Mercedes-Benz

service information

REF. NO. 30/11A

SUBJECT: **MODELS 124.034/036 (ENGINE 119.974/5)**
ROUTING OF EA/CC/ISC ACTUATOR HARNESS

Figure 1 Model 124.036

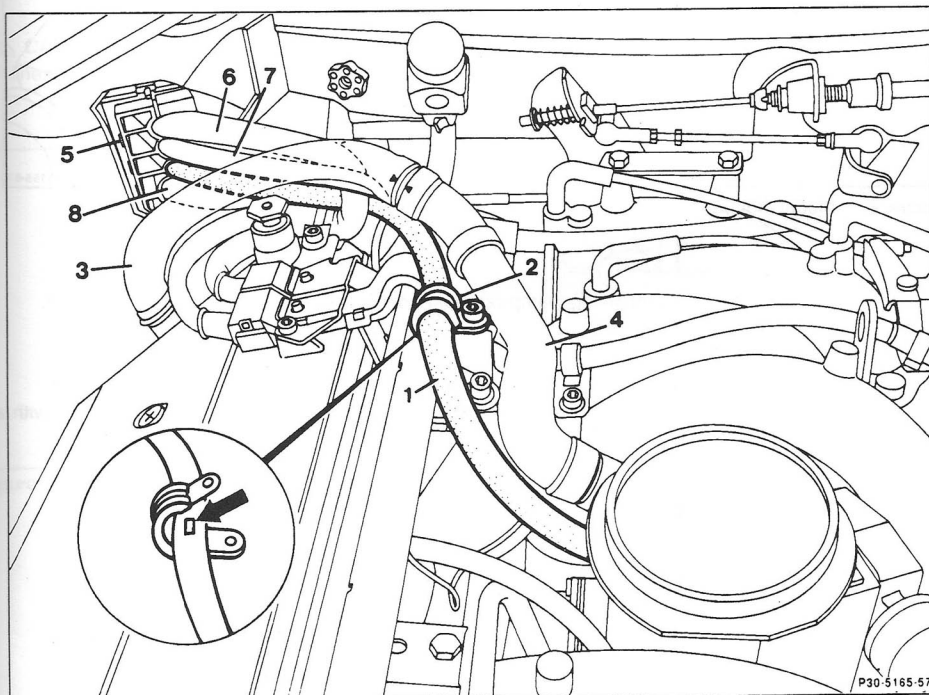
On model 124.036, the harness (1) must be routed as shown in Figure 1, under the formed hoses for crankcase ventilation (3 and 4) and then through the hinged grommet (5, Figure 1).

The harness (1) as well as the mounting clamp (2) must be installed as depicted in Figure 1 and 2.

The white mark on the actuator harness (arrow) must be positioned inside the mounting clamp (2, Figures 1 and 2). In this case, the familiar mark on the circumference of the harness is replaced with a white rectangle.

Figure 3

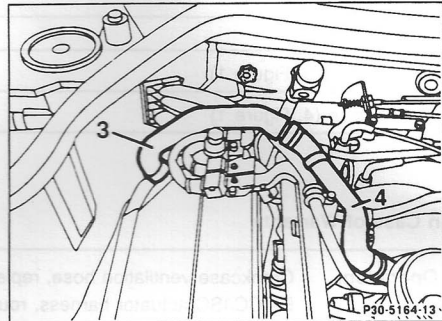
On vehicles up to engine end number 001910, replace formed hoses for crankcase ventilation (3 and 4, Figure 3) and route according to layout shown in Figure 3.

Figure 4

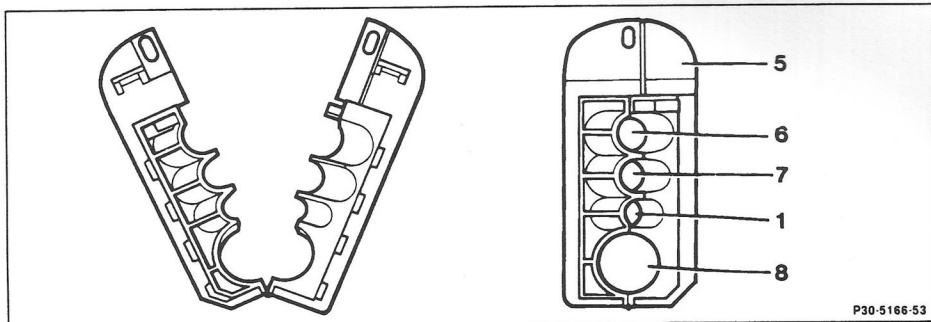
Route all electrical harnesses (1, 6, 7, Figure 1) as well as the engine coolant return line for the heater (8, Figure 1) through holes (6, 7, 1, 8, Figure 4) in the hinged grommet (5, Figure 4). Reconnect hinged grommet by pressing together.

All lines running through the hinged grommet must be positioned in the correct holes (Figure 4).
